Rezoning Transportation Analysis

Petition Number: 2025-124

Revision Log:

Date	Description
12-22-25	First Review (CM)
01-22-26	Second Review (CM)

Local collector street (6' sidewalk) CLDSM U-07A

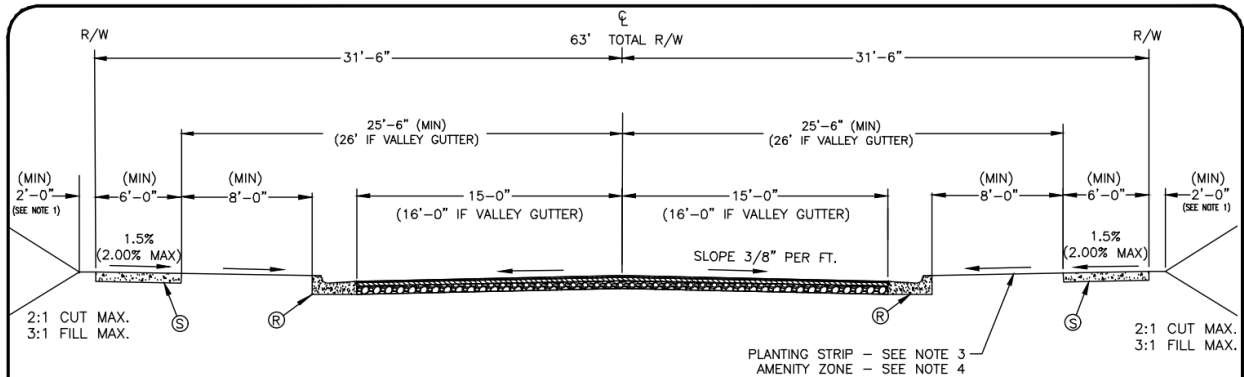
- a. **McKee Road:** Location of future curb and gutter is to be located 17.5' from centerline.

Label and dimension the curb and gutter from the centerline for each road on the site plan.

Local residential medium street (6' sidewalk) CLDSM U-02A

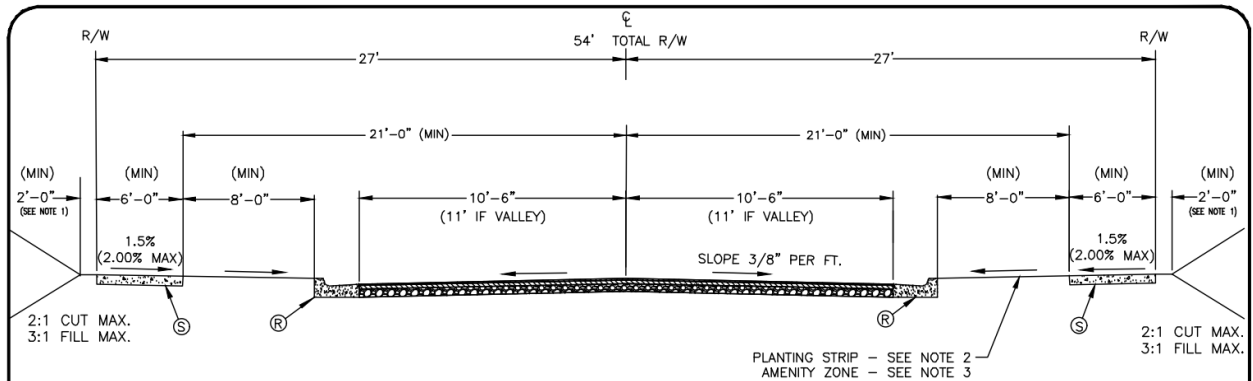
- b. **Internal Public Roads:** Location of future curb and gutter is to be located 13' from centerline.

Clarifying Comment 01-22-26: Label London Pass as CLDSM U-02A on site plan.

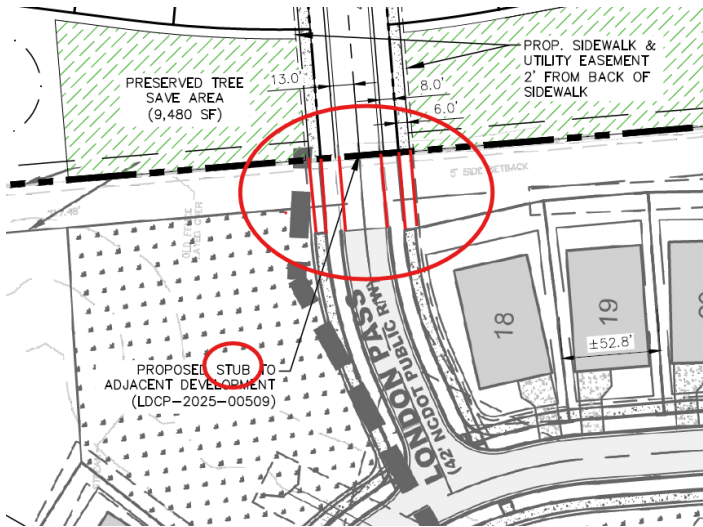
6. Revise site plan and conditional note(s) to commit to making London Pass roadway and sidewalk connection to adjacent project. Conditional note can also include language that if adjacent project is not constructed before this project improvements shall be constructed as close as possible to property line as feasible to prepare for future road connection.

Clarifying Comment 01-22-26: To match the updated Transportation conditional note 6, show the sidewalk and roadway being connected to London Pass roadway and sidewalk on adjacent parcel and revise plan callout to read proposed "connection" to adjacent development LDCP-2025-00509).
